**Sur-Rebuttal Analysis  
of the Applicant's  
Experts' Rebuttal Opinions**

By  
Dr. Willem A. Schreüder & Dr. Devraj Sharma  
Principia Mathematica Inc.

June 19, 2000

Case No. 96CW014: Application for Water Rights by Park County Sportsmen’s Ranch, LLP

Figure SR-1a.

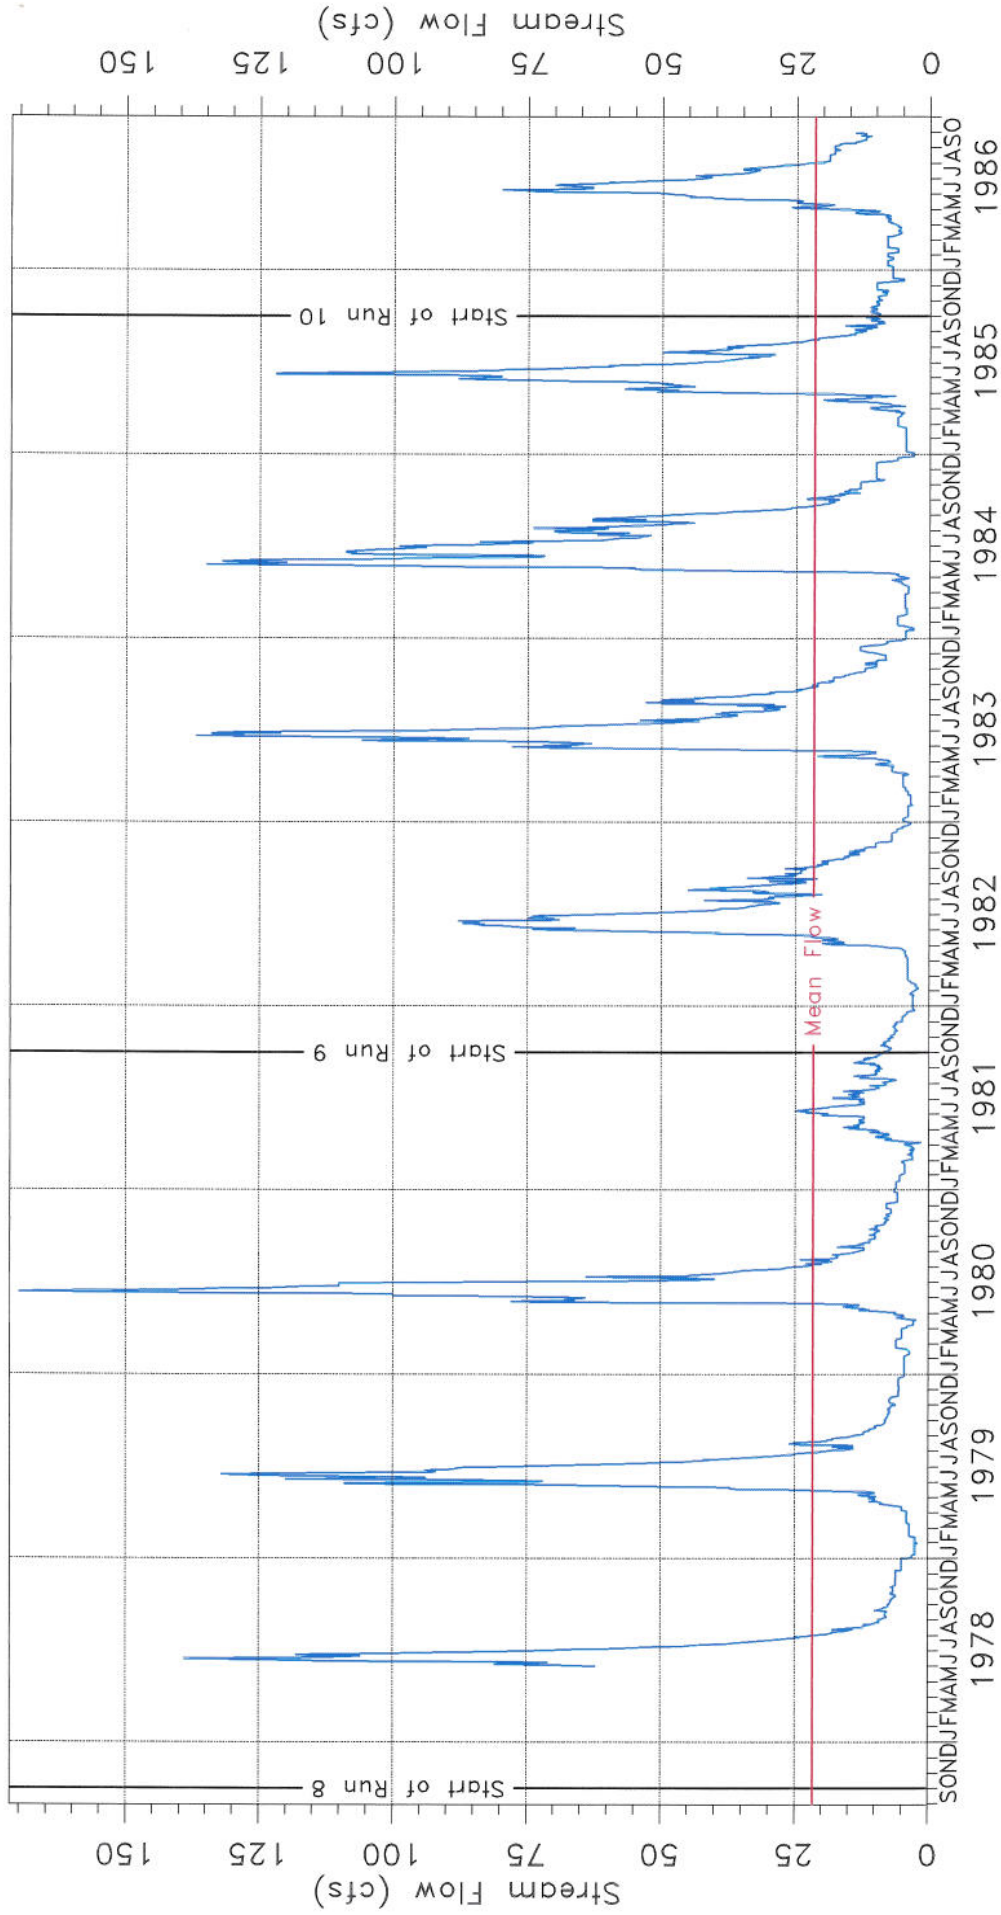
- (19) Notwithstanding the rebuttal opinions offered by the Applicant’s experts [*see JWC, 2000b, Part-II, p47, p48, p49*], the predictions of stream-aquifer interactions and stream depletions made by the Applicant’s ground water model are fatally flawed. Sur-rebuttal analysis conducted by Principia of the Applicant’s NOCUP model simulation clearly demonstrate that the streams flowing through South Park, even as poorly represented in the Applicant’s ground water model, exhibit substantial sensitivity to the prescription of stream stage in model grid cells. Figure SR-1a illustrates the gaged flow in Tarryall Creek near Como, used for purposes of such sensitivity testing. The depth of water in this stream is related to its stream flow by a power-law expression. This expression dictates the fact that the daily average depth will not equal the depth calculated from the daily average flow rate for any other span of time. Figure SR-1b illustrates the stream-aquifer interactions, i.e. gains and losses, calculated by the model during its NOCUP9a run conditions for three possible stage prescriptions. The first, depicted by a red line is simply the result of constant-stage prescription exactly as used by the Applicant and defended as appropriate and proper by the Applicant’s rebuttal experts. The second, depicted by a green line, involves the calculation

and use in the model of a monthly-average stream stage. The third, depicted by a blue line, involves the calculation and use in the model of a daily-average stream stage based upon stress periods of one day. It may be observed in this figure that the stream-aquifer interaction calculated by the Applicant's model for changes in just this variable, are very significant., thus demonstrating that the model is incapable of predicting stream depletions in time, place and amount with any reliability.

Figure SR-2a.

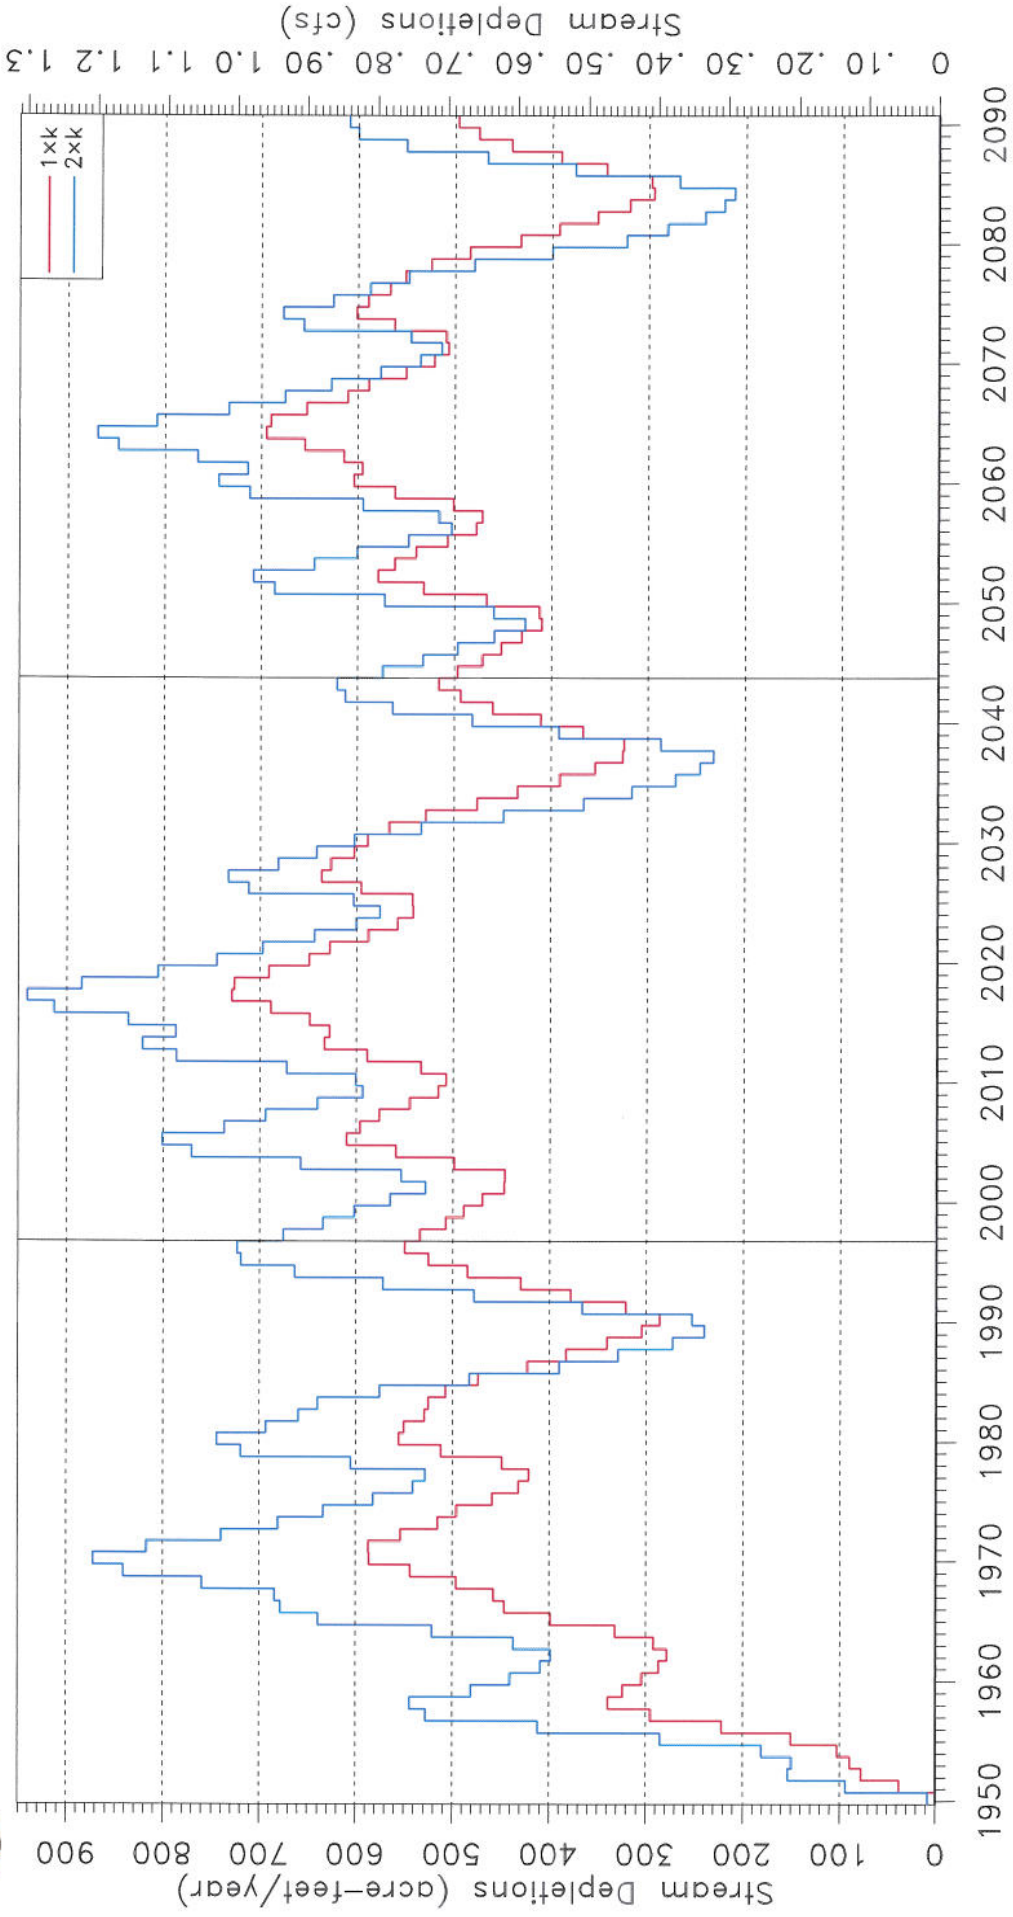
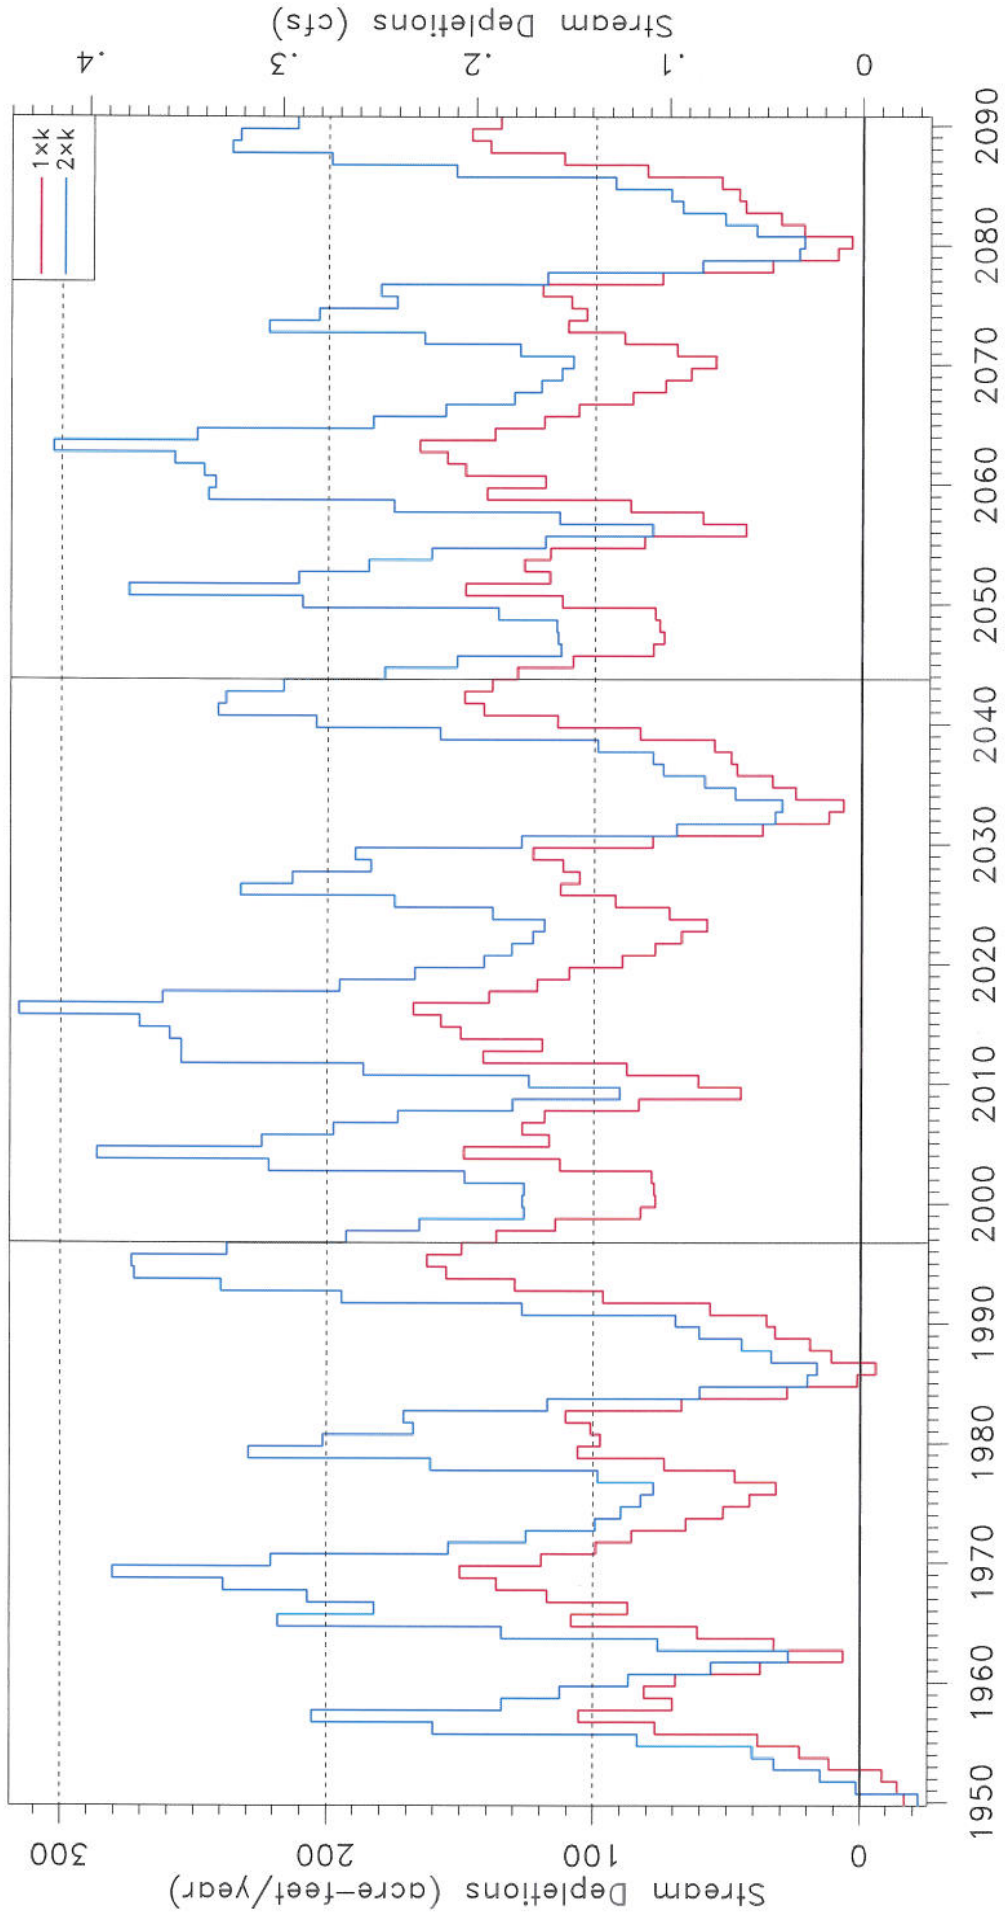
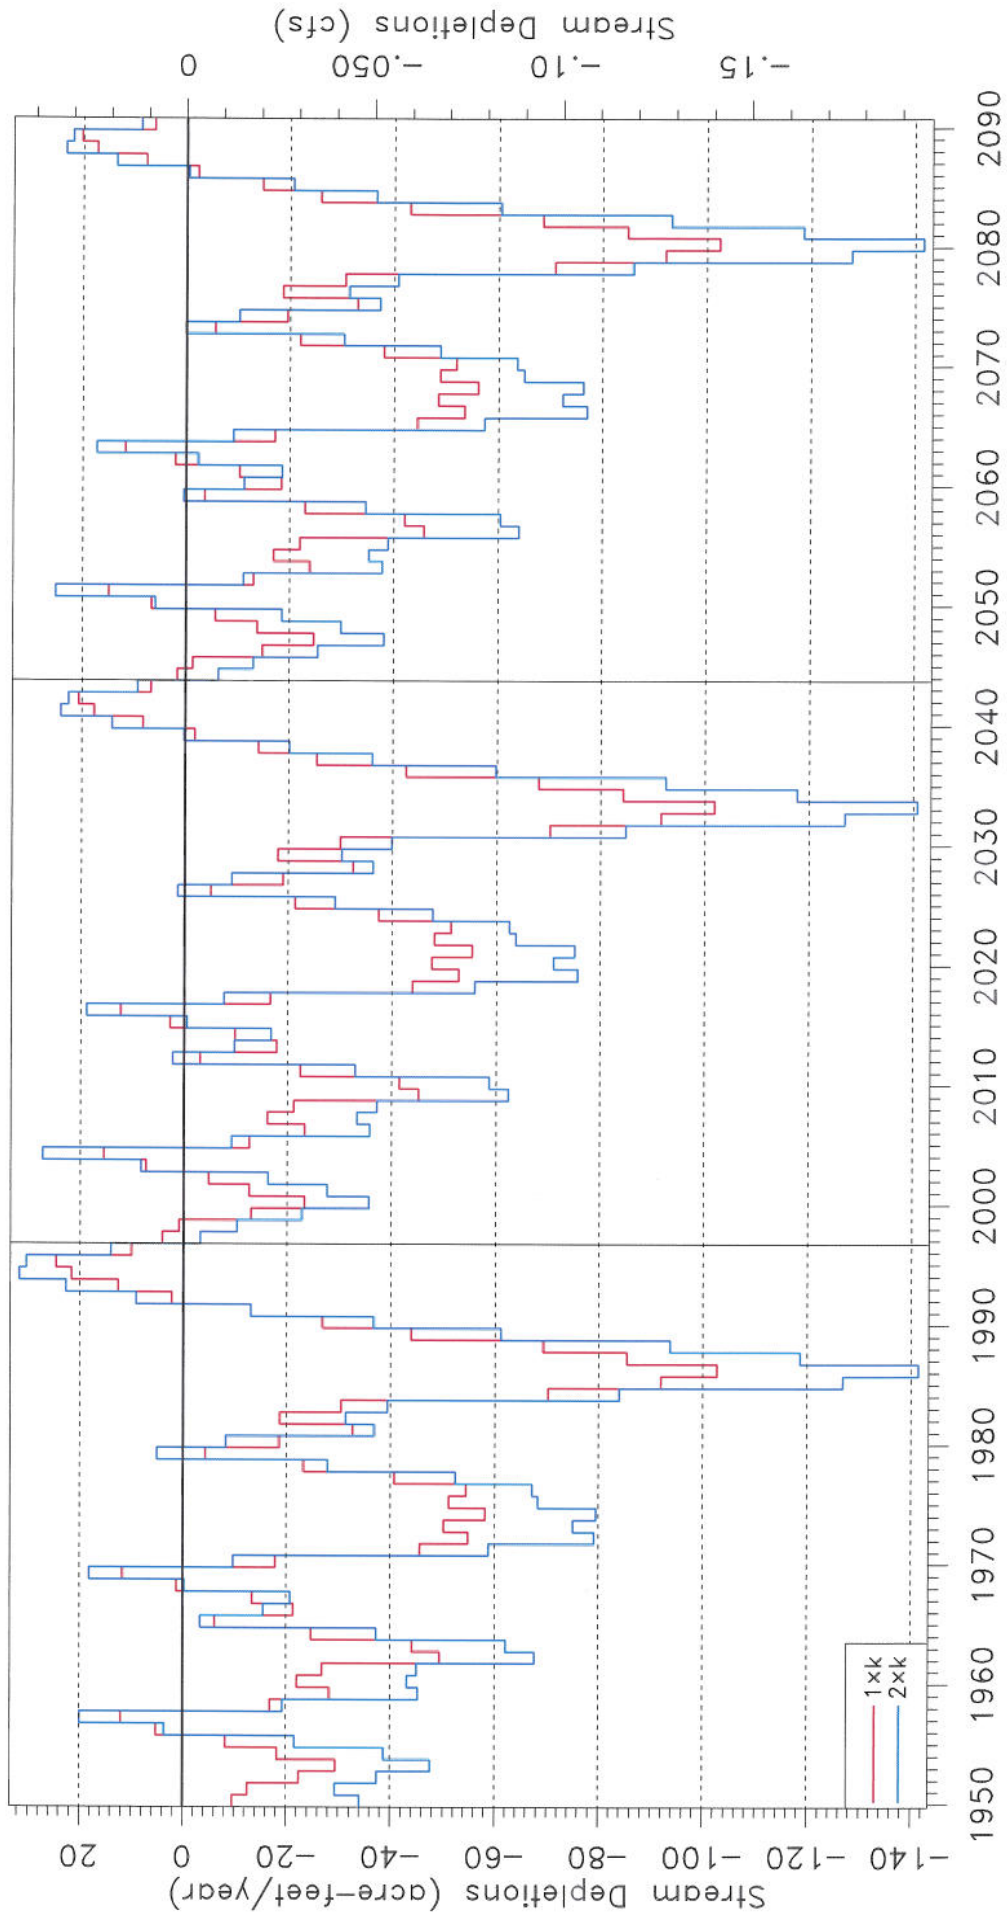
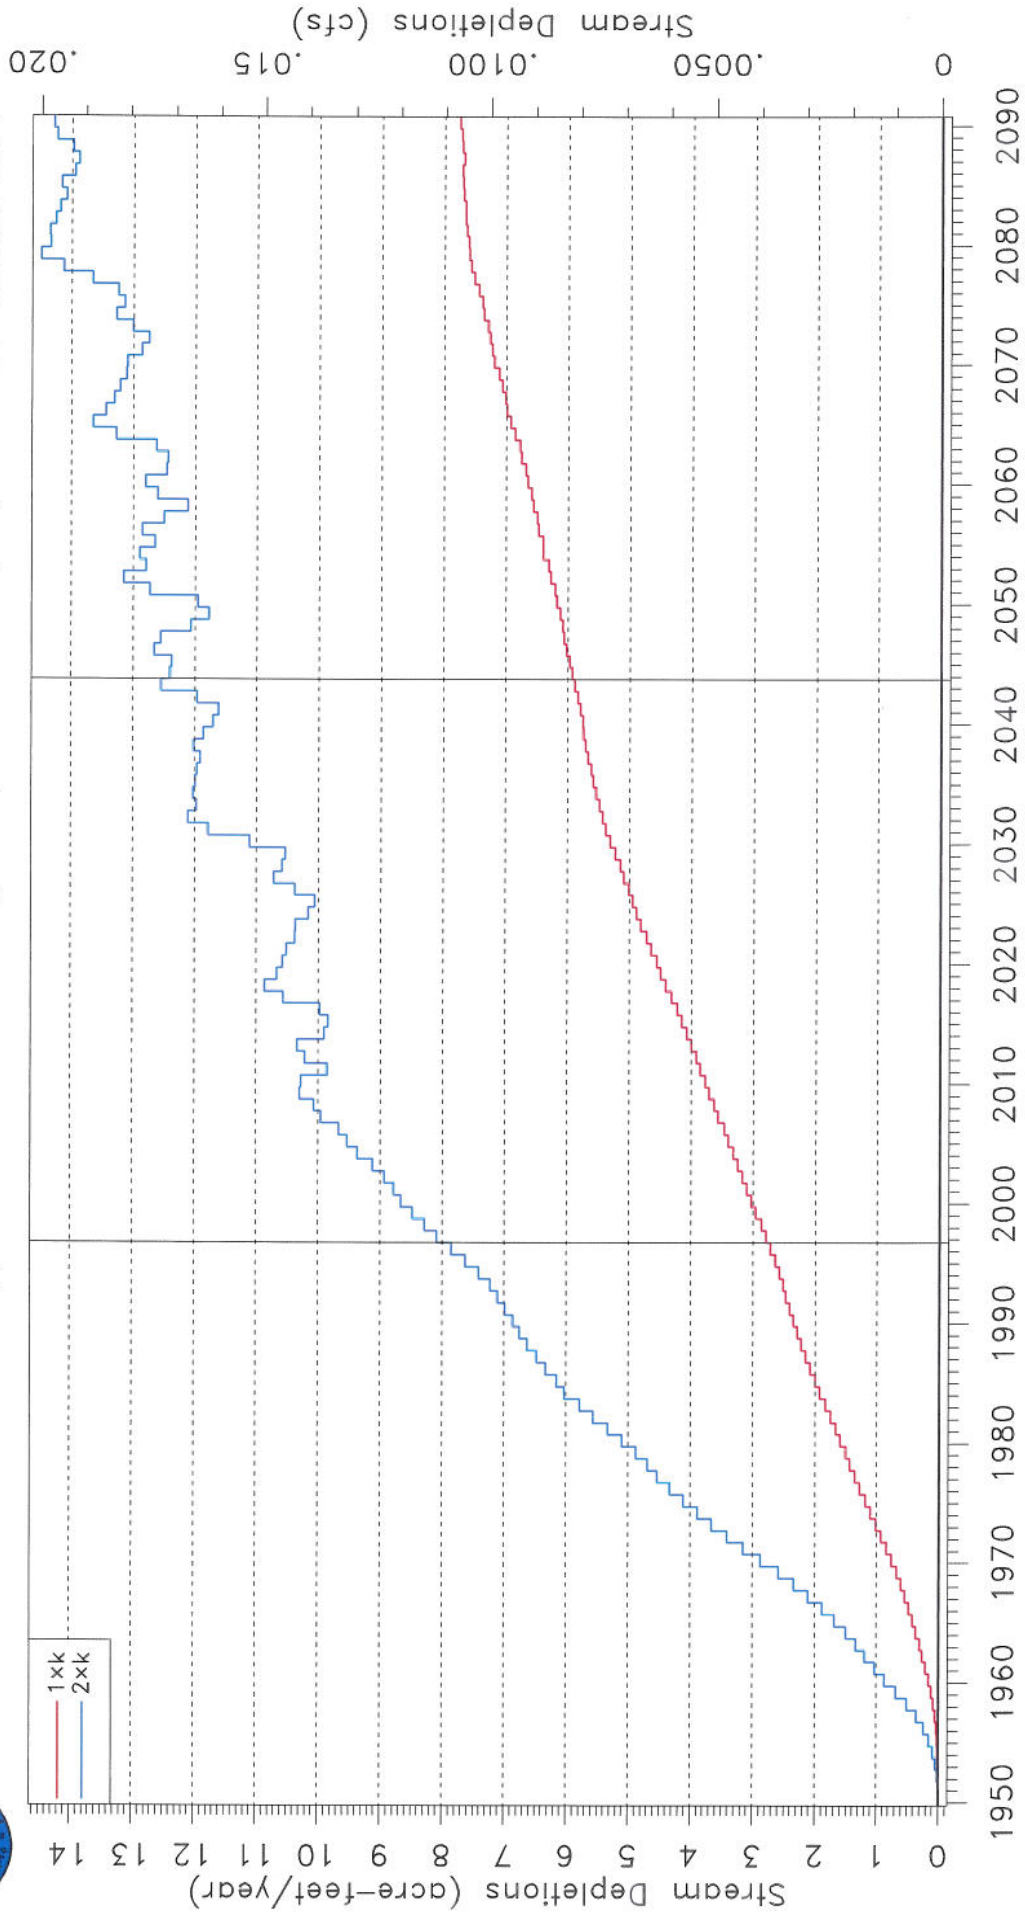
- (20) Notwithstanding the rebuttal opinions offered by the Applicant's experts [*see JWC, 2000b, Part-II, p47, p48, p49; van der Heijde Deposition, Vol-3; Eastman Deposition, Vol. 6*], the predictions of stream depletions made by the Applicant's ground water model remain fatally flawed. Principia's sur-rebuttal analysis has clearly demonstrated that the depletions to streams flowing through South Park, as predicted by the Applicant's model, are extremely sensitive to even minor variations in hydraulic conductivity of the aquifer materials through which they flow. Examples are presented in Figure SR-2a through Figure SR-2e of five different streams in which the increases and even decreases to predicted depletion caused by hydrogeologically small changes to the prescribed hydraulic conductivity values, can be clearly observed. Principia's sur-rebuttal analysis is corroborated by sensitivity analysis only recently conducted by RMC as reported in their June 6, 2000 memorandum.
